[Docket No. 97-NM-298-AD]

Airworthiness Directives; McDonnell Douglas Model DC-9, DC-9-80, and C-9 (Military) Series Airplanes; Model MD-88 Airplanes; and Model MD-90 Airplanes

ACTION: Supplemental notice of proposed rulemaking; reopening of comment period.

Figure 1

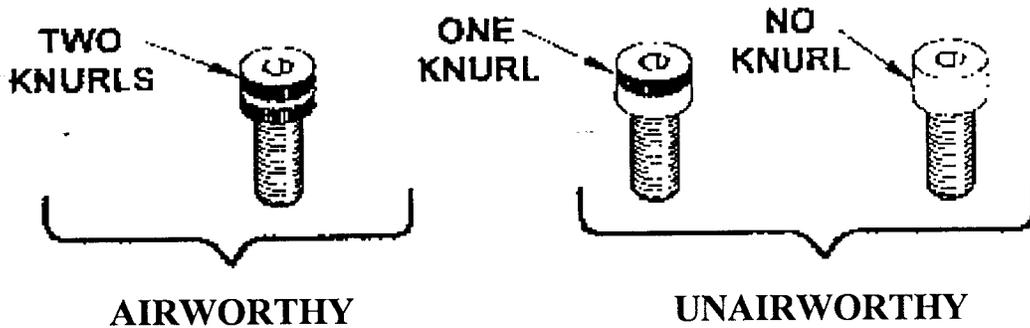
(a) Visually inspect each #10-32 screw in the battery at the terminals to verify that each screw has two (2) rows of straight knurls (see Figure 1). If a screw is found with only one knurl or no knurl (see Figure 1), before further flight, fully discharge the battery, remove the unairworthy screw and replace it with an airworthy screw, P/N 10488-020.
